Model: Ring Binder RB5000	Date: 20-June -08	No.: RD392001a
---------------------------	-------------------	----------------

Subject: Firmware Release Note: Ring Binder_B1		Prepared by: T.Tadokoro	
From: PPBG QA/Service Planning Dept.			
Classification:	<input type="checkbox"/> Troubleshooting <input type="checkbox"/> Mechanical <input type="checkbox"/> Paper path <input checked="" type="checkbox"/> Other (      )	<input type="checkbox"/> Part information <input type="checkbox"/> Electrical <input type="checkbox"/> Transmit/receive	<input type="checkbox"/> Action required <input type="checkbox"/> Service manual revision <input type="checkbox"/> Retrofit information

Model: Model: Ring Binder RB5000		Date: 8-Jun-09	No.: RD392003a
Subject: Bracket:Coupling:Main:Ass'y		Prepared by: Nobuo iida	
From: PPBG QA/Service Planning Dept.			
Classification:	<input type="checkbox"/> Troubleshooting <input type="checkbox"/> Mechanical <input type="checkbox"/> Paper path <input type="checkbox"/> Product Safety	<input checked="" type="checkbox"/> Part information <input type="checkbox"/> Electrical <input type="checkbox"/> Transmit/receive <input type="checkbox"/> Other (     )	<input type="checkb

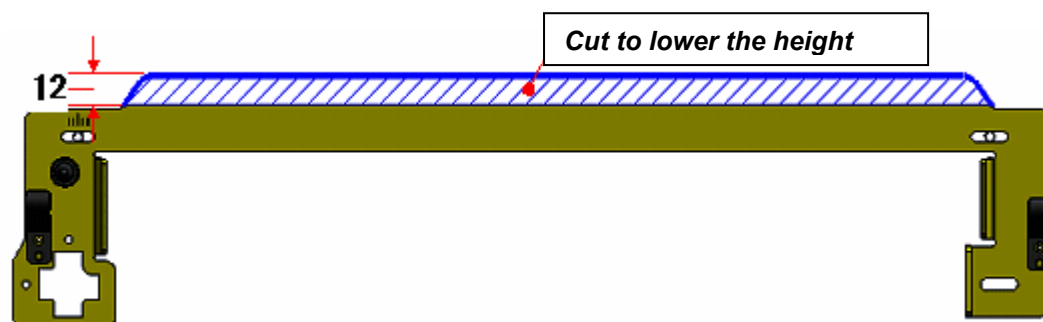
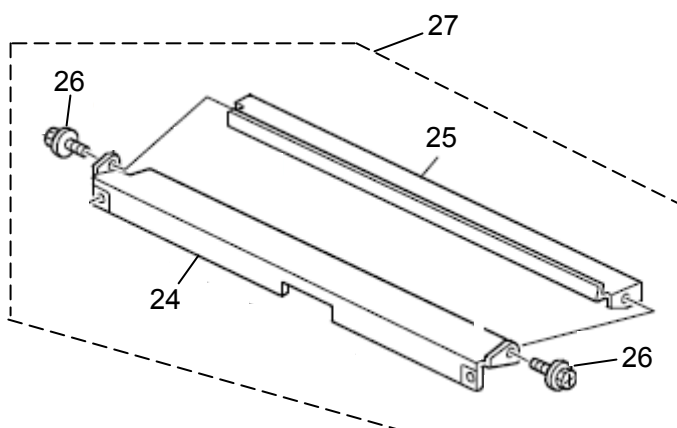
Change: Shape of the Bracket:Coupling:Main:Ass'y

Reason: To enable direct installation of the Ring Binder onto the Aegis mainframe

The docking bracket included in the Ring Binder package is applied to install the Ring Binder directly onto the Aegis mainframe, but the device could not be installed due to interference with the Decurler Unit. The shape of this bracket has been changed as shown below to resolve this problem. The modified bracket is included in the Ring Binder package from November 2008 production.

When installing the Ring Binder directly onto the Aegis mainframe, please install a Ring Binder of production after November 2008.

If you must use a Ring Binder that does not have this modification, please procure the modified docking bracket "D4341476" to enable installation.

## Added to Sections

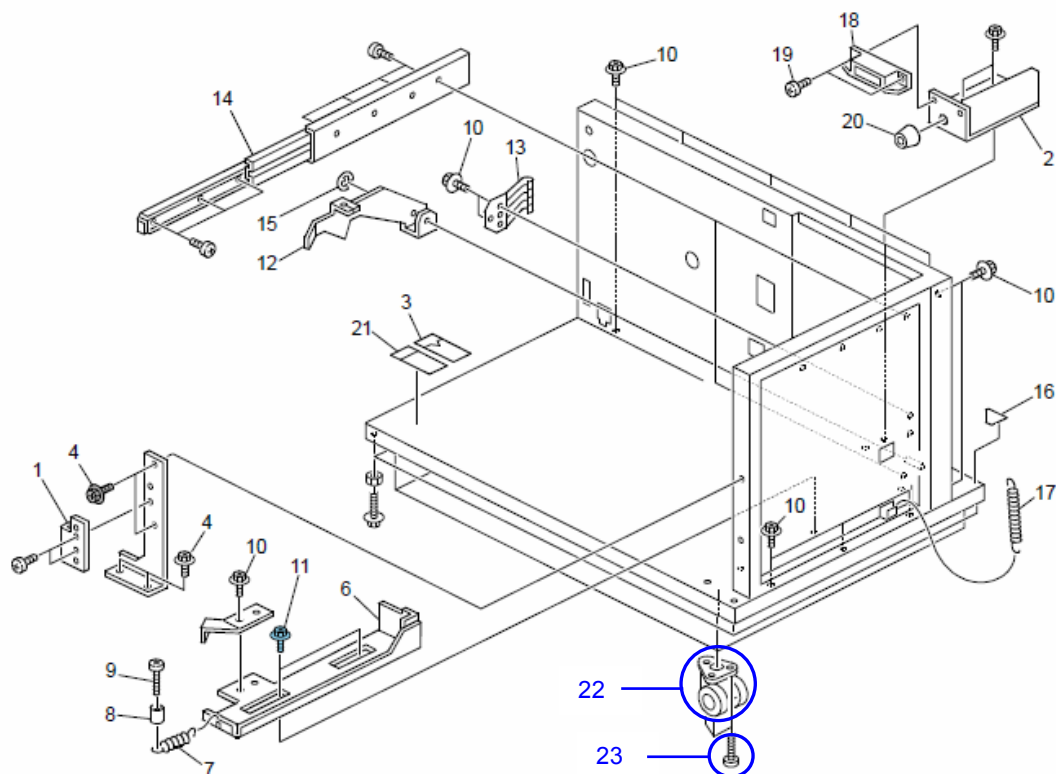
When adjusting SP6504, close the front door of the Ring Binder.

After the adjustment, keep the front door of the Ring Binder closed and turn the main power switch OFF and ON.

- a. Replacement and Adjustment > Common Procedure > SP6504 Adjustment.
- b. Replacement and Adjustment > Boards > Main Control Board.

**Replacement procedure**

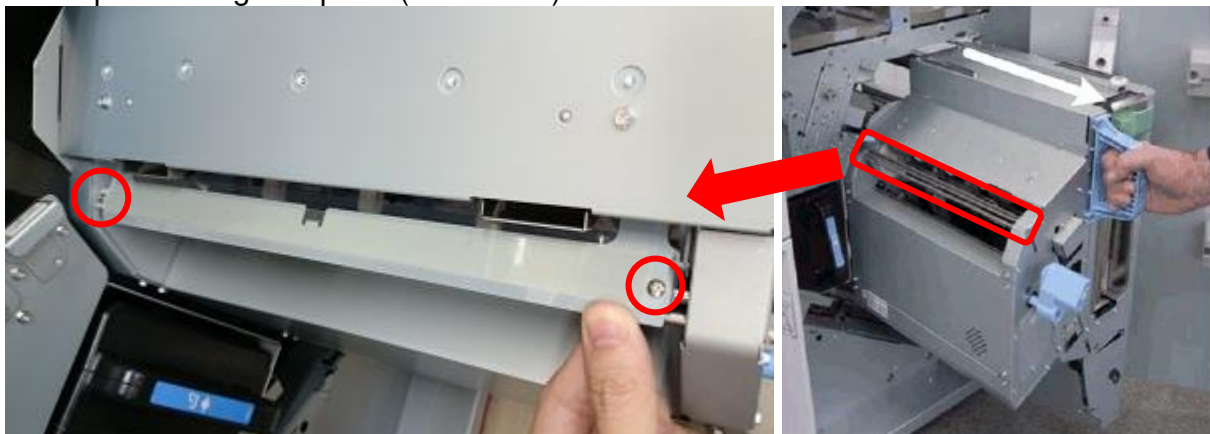
The following guide plate attached with a Mylar sheet was registered as a service part to meet requests received from the field.

1. Pull out the Binder Unit.

2. Replace the guide plate (screws x2).

3. Slide the Binder Unit back in to complete the procedure.
